# HAL300 Differential Hall Effect Sensor IC

Edition July 15, 1998  
6251-345-1DS

<b>Subject:</b>	Improvement of SOT-89B Package
<b>Data Sheet Concerned:</b>	HAL 300, 6251-345-1DS, Edition July 15, 1998 HAL 320, 6251-439-1DS, Edition July 15, 1998
<b>Supplement:</b>	No. 1/ 6251-532-1DSS
<b>Edition:</b>	July 4, 2000

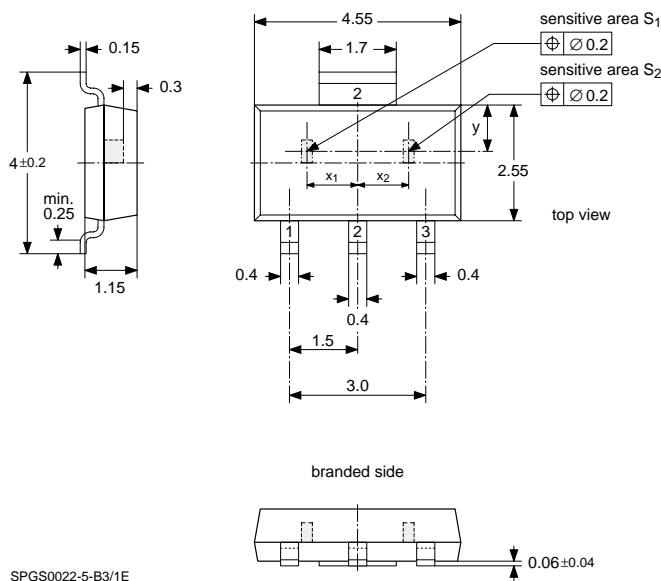
- position tolerance of the sensitive area reduced
- tolerances of the outline dimensions reduced
- thickness of the leadframe changed to 0.15 mm (old 0.125 mm)
- HAL 300 now available in SOT-89B
- SOT-89A will be discontinued in December 2000

**Position of sensitive area**

HAL 300	HAL 320
$x_1+x_2$	(2.05±0.001) mm	(2.25±0.001) mm
$x_1= x_2$	1.025 mm nominal	1.125 mm nominal
y	0.95 mm nominal	0.95 mm nominal

**Note:** A mechanical tolerance of ±0.05 mm applies to all dimensions where no tolerance is explicitly given. Position tolerances of the sensitive areas are defined in the package diagram.
